Eastern Bay Link Road Queens Gate Roundabout Road Safety Audit (Stage 2)

October 2016

Doc Ref: EBL-CAP-0000-QGR-SA-C-0205

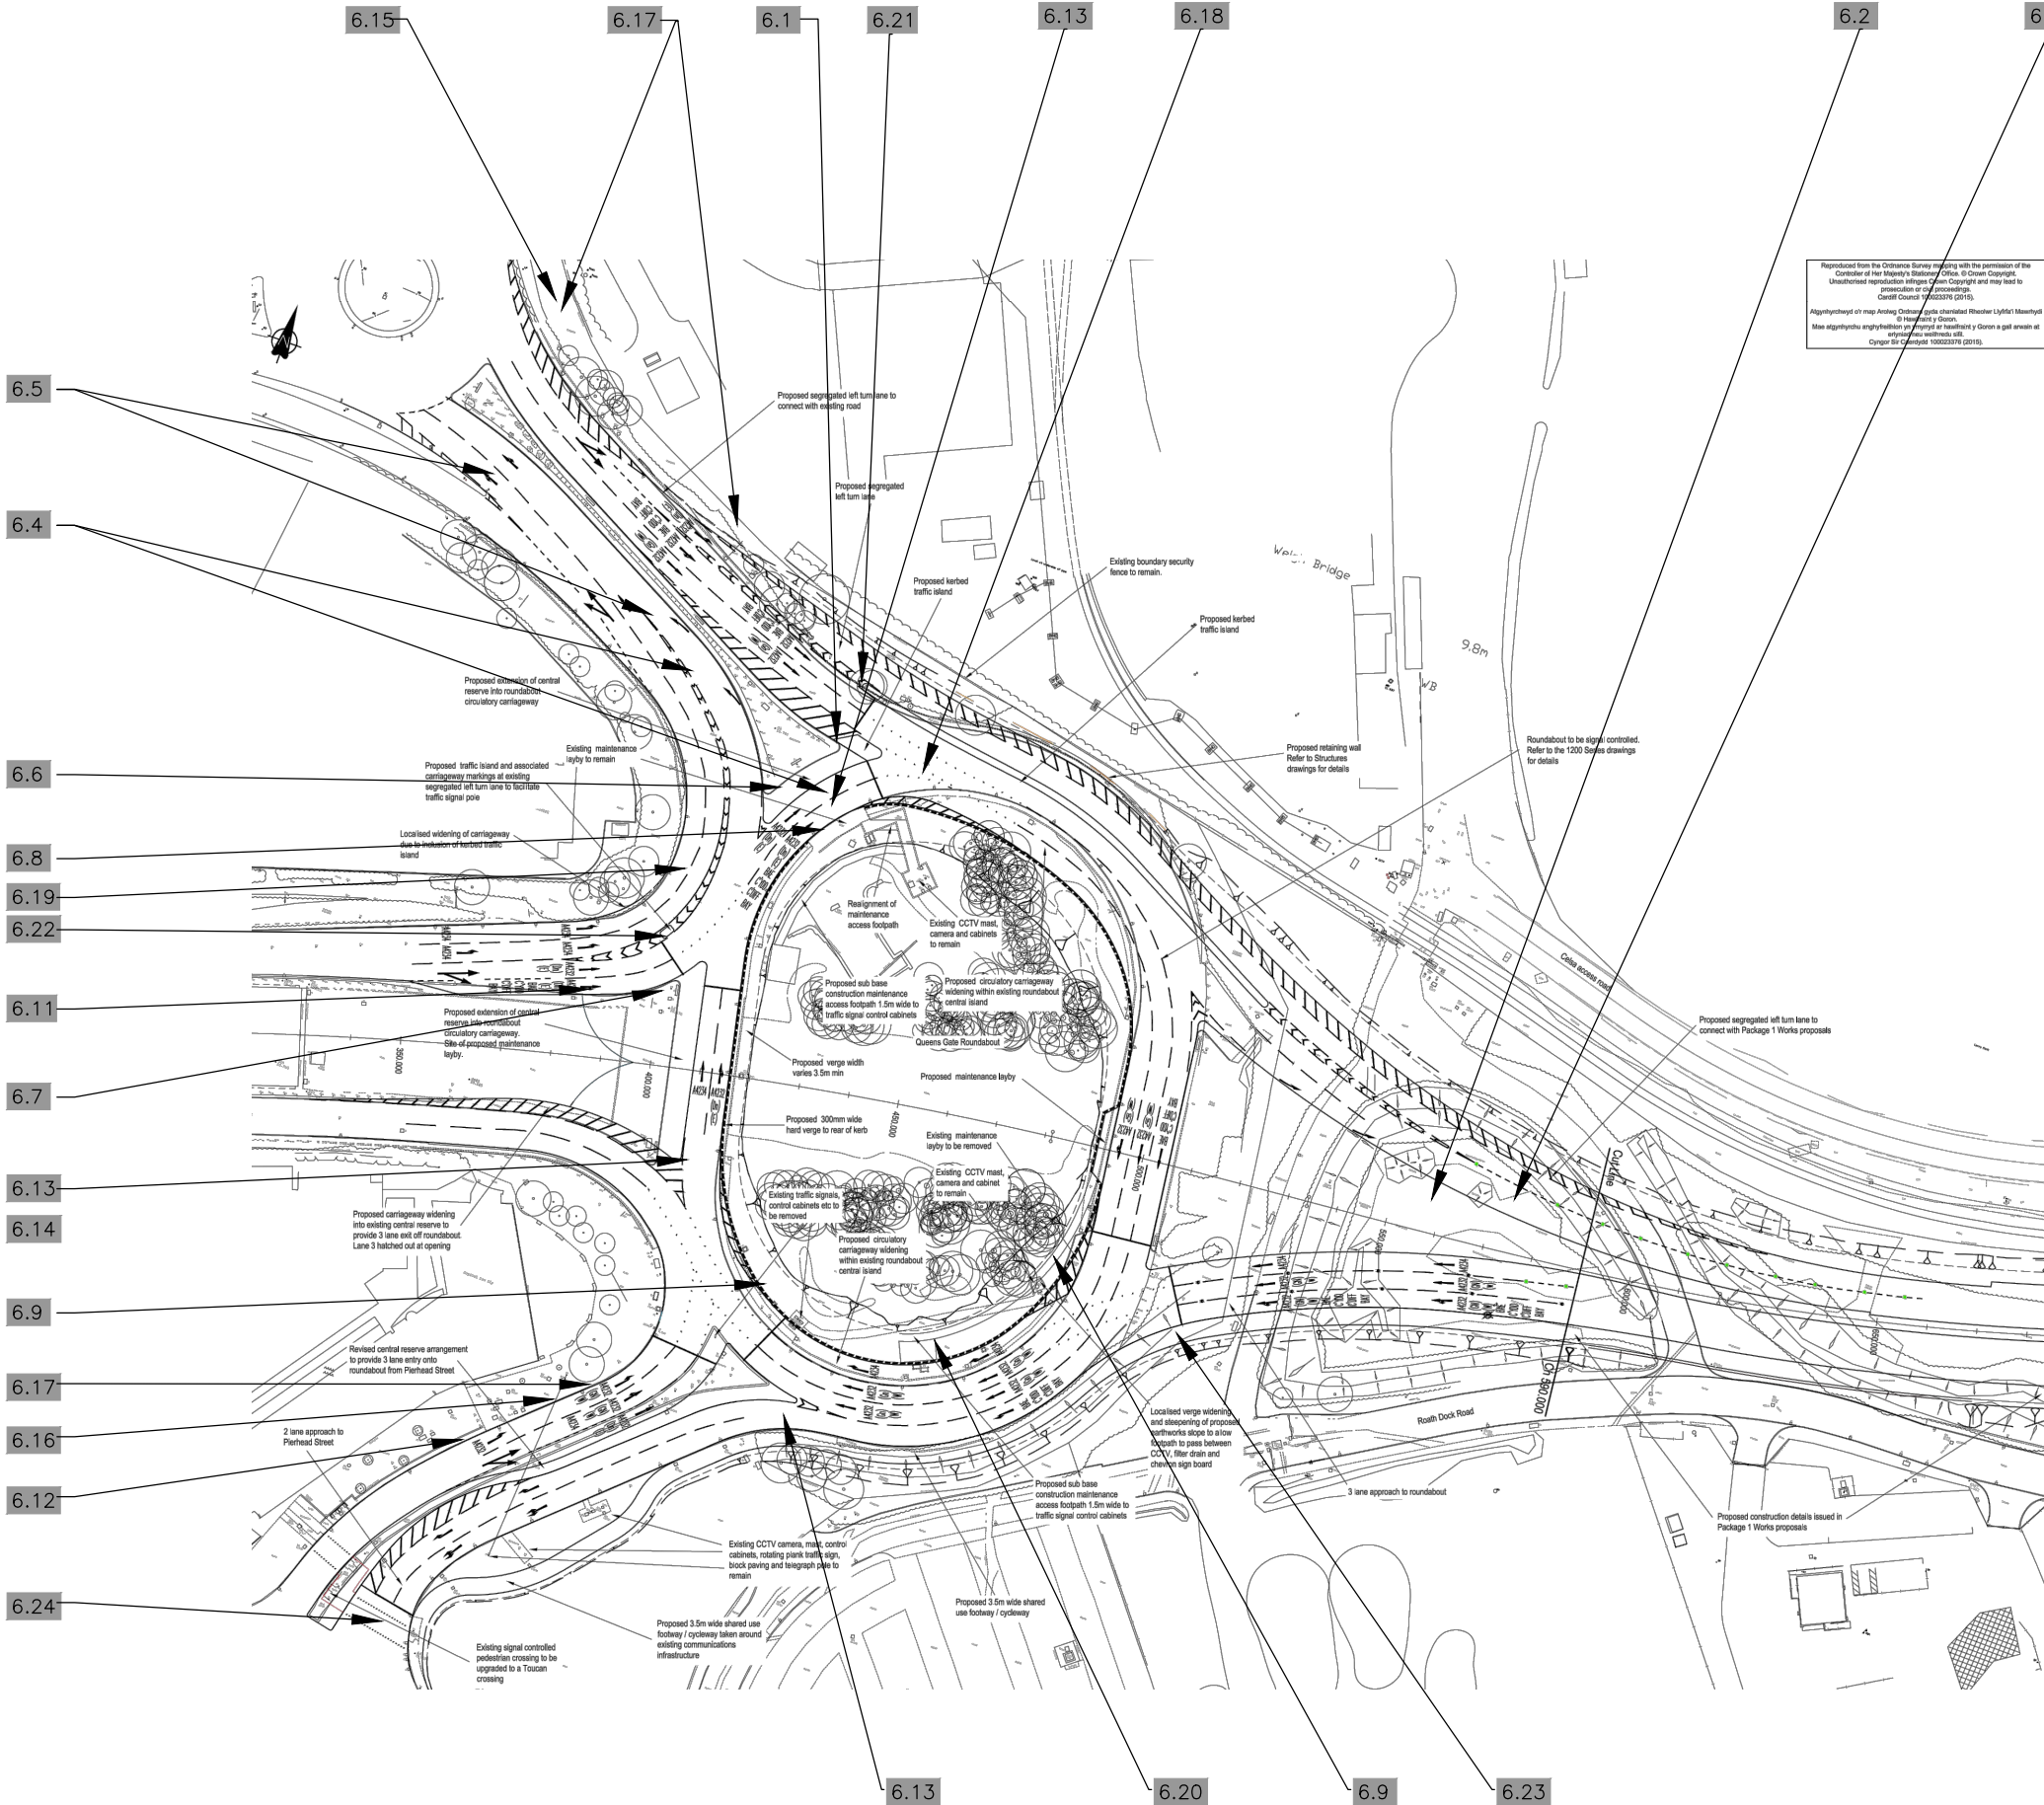
On the A4234 eastbound approach to the roundabout from the City centre there is a kerb build out on the offside and road levels fall towards this kerbline where no drainage is provided. Flooding in the vicinity of the signal Stop line may result in skid related collisions.

P1 terminal provided on the central island on the offside of the eastbound carriageway exiting from Queens Gate roundabout towards EBL Main Line may launch an errant vehicle, leading to overturning collisions.

The exit taper to the segregated left turning lane runs in parallel to the eastbound exit from the roundabout to EBL Main Line where two lanes merge into one. In view of the multitude of merging manoeuvres, drivers merging on the roundabout exit may fail to notice vehicles changing lane from the segregated left turning lane to the offside lane, leading to potential side impact collisions.

In the north western circulatory carriageway at the tightest radii, the circulatory carriageway width is 8m and this arrangement may lead to larger vehicles encroaching into the adjacent lane in conflict with other vehicles. This problem was originally raised during the Stage 1 Road Safety Audit, but has not been addressed.

There is a potential for conflict between eastbound vehicles exiting the roundabout towards the A4234 City centre while undertaking merging manoeuvres into one lane and vehicles coming from the A4232 Tunnels in the segregated left turn lane and heading towards the City centre. Potentially vehicles from the three lanes could merge into one offside lane on the approach to the Central Link roundabout. Subsequent side impact collisions may occur.

On the north-western side of the roundabout circulatory carriageway a Splay type kerb is proposed on the nearside along the central island of the A4234 arm. Vehicles will negotiate a tight curvature on the two lane approach to the signals at this location and, if they mount this kerb, they could overrun the verge colliding with traffic signal posts positioned in the adjacent verge.

Vehicles will negotiate a tight curvature on the two lane approach to the signals on the A4232 eastbound approach from the Tunnel to the roundabout. There is a Splay type kerb proposed on the offside, as a result, vehicles approaching in two lanes may overrun the splay kerb and collide with traffic signals on the island.

The kerb upstand is shown at 125 mm (Splay type kerb) at the access to the CCTV maintenance layby on the north western side of the roundabout central island. This kerb upstand will force maintenance vehicles to slow down to a stop to access the layby, leading to potential rear end shunt collisions with following vehicles.

Chevron boards QGR2-WS facing westbound traffic on the EBL Main Link approach and QGR3-WS facing northbound traffic on Caspian Way approach to the roundabout are offset to the left from the line of sight of approaching drivers. Incorrect positioning of chevron boards on the central island of the roundabout may cause drivers to misjudge the roundabout and turn right on the entry against the movement, particularly in view of the traffic signals on the approaches.

'Wicket' lane destination direction signs throughout the scheme indicate Cardiff Bay by a 'Theatre' symbol, although, numerous journeys will be made towards residential areas in Cardiff Bay. Some drivers unfamiliar with the area may be confused by this symbol, leading to lane changes and side impact collisions.

Right turn arrow is proposed on the A4232 eastbound approach to the traffic signals at Queens Gate roundabout. The right turn arrows on the roundabout approach may be misinterpreted by users, particularly foreign lorry drivers who may turn at the junction in collision with head on vehicles. This problem was originally raised during the Stage 1 Road Safety Audit, but has not been addressed for this roundabout approach.

Numerous signs are positioned in the nearside of the Caspian Way approach to the roundabout which may interfere with visibility toward the nearside primary traffic signals. The direction signs 28 RPS and QGR4-DS are of substantial dimensions and may obscure forward visibility toward the signal heads. The sign clutter may cause drivers to misjudge the approach, brake sharply, leading to rear end shunt collisions.

Proposed hatched markings on approaches to traffic islands may lead road users into the kerbs if these are not offset from the kerblines. This marking layout may cause collisions with the islands, particularly in dark conditions.

Hatched markings on the approach to the central island alongside the A4232 westbound exit towards the Tunnel is shown incorrectly and may confuse drivers, who could be guided to the roundabout exit instead of staying on the circulatory carriageway. This layout may lead to sudden lane changes and side impact collisions.

The proposed map type advance direction sign 21-RPS facing eastbound traffic on the A4234 approach to the roundabout could give a misleading message to drivers. It indicates that vehicles travelling towards the M4E/A48 will be turning left and those proceeding towards Cardiff Bay will be continuing straight on. This layout does not correspond with the true layout of the junction and its exits. As a result, drivers intending to travel to Cardiff Bay may exit towards the M4E/A48 and drivers travelling towards the A4232/M4W may exit towards Cardiff Bay. The sign layout may cause confusion, sharp braking, sudden lane changes and subsequent rear end shunt and side impact collisions.

The proposed 'wicket' sign QGR 4-DS does not correspond with the lane destination carriageway markings on Caspian Way approach to the junction. Inconsistency in signing and markings may cause driver confusion, sudden lane changes and subsequent side impact collisions.

Numerous signs in the nearside verge of the A4234 eastbound approach to the roundabout, e.g. OGR 3-RS, QGR1-TMP, 21 RPS and QGR 1 –DS, may overlap one another, causing drivers to miss the information indicated by the signs. This layout may cause late lane changes and side impact collisions.

Proposed 'elephant foot' markings on the circulatory carriageway leading from the traffic signals Stop line at the intersection with the A4234 entry marked as follows: A4232 E in the outside lane and A4232E/Cardiff Bay in the inside lane. However, 'elephant foot' markings will lead motorists into incorrect lanes and could result in lane swapping and side impact collisions.

The width of the segregated left turn lane from the tunnel (A4232) direction is below 8m for 2 lanes taken around a tight curvature. Larger vehicles may encroach into adjacent lane and hit the island. This problem was originally raised during the Stage 1 Road Safety Audit, but has not been addressed.

Proposed traffic signal controller area on the southern side of the central island could obstruct forward visibility for circulating vehicles and lead to sudden braking and rear end shunt collisions with vehicles stopping at the signals.

Proposed signal head SP12 on the segregation island facing eastbound traffic on the A4234 approach to the roundabout may be confusing to drivers in the segregated left turn lane. Drivers may brake sharply on seeing a red signal leading to rear end shunt collisions with following vehicles.

Proposed signal head SP8 on the segregation island facing eastbound traffic on the A4232 approach from the Tunnel may be confusing to drivers in the segregated left turn

lane. Drivers in the segregated left turn lane may brake sharply on seeing a red signal leading to rear end shunt collisions with following vehicles.

Nearside primary traffic signal head SP17 is located in the middle of the shared footway/cycleway and may become an object of collision for pedestrians and cyclists.

There is a possibility of pedestrians cutting across the proposed staggered Toucan crossing in the absence of guard railing. If traffic moves on separate phases along Caspian Way pedestrians may be in conflict with vehicles.

Provide adequate drainage.

Provide a P4 terminal instead of P1.

Provide straight ahead lane destination arrows on both lanes and extend hatched markings, separating the segregated lane from the roundabout exit further south to minimise the likelihood of conflicts during the lane changing manoeuvres.

Check swept paths and widen lanes if necessary.

Provide a merge on the exit from the segregated left turn lane with associated markings giving the traffic exiting the Queens Gate roundabout priority.

Replace SP splay kerb with BN3 type along the central island.

Replace SP splay kerb with BN3 type along the central island.

Provide BN2 type kerb at the layby.

Relocate chevron boards to the right to be in line with the driver's sight on the approach.

Provide abbreviated Cardiff Bay wording instead of the 'Theatre' symbol.

Do not provide right turn lane arrow and replace with straight on arrow.

Position the signs outside the visibility splay and remove the proposed warning sign of Traffic Signals Ahead QGR8-WS, as it is positioned too close to the signal heads and could attribute to sign clutter.

Ensure markings are offset and deflect vehicles from the island kerbs.

Correct the hatched markings introducing chevron markings deflecting traffic from the island on both sides.

The proposed ADS should be modified to depict a true layout of the roundabout with the straight on arm towards the M4E/A48 and right hand arm leading to Cardiff Bay.

It is recommended that the lane destination sign QGR 4 – DS corresponds with the lane destination markings on the approach to the junction.

Position the signs on site so that they do not mask one another.

Re-align the 'elephant foot' markings to ensure that vehicles in the inside lane are guided into the middle lane on the circulatory carriageway and vehicles in the outside lane continue in the outside lane.

Check swept paths, particularly larger HGV's.

Relocate the controller area outside the visibility splay

Provide hoods/louvres to the traffic signal head to make it less visible to drivers in the segregated left turn lane.

Provide hoods/louvres to the traffic signal head to make it less visible to drivers in the segregated left turn lane.

Relocate the traffic signal to the back of the shared route.

This location should be monitored by Cardiff County Council for the 12 month period following scheme construction and, if problems occur, either guard railing or mini-planters should be provided on desire lines to prevent pedestrians from walking across the carriageway.
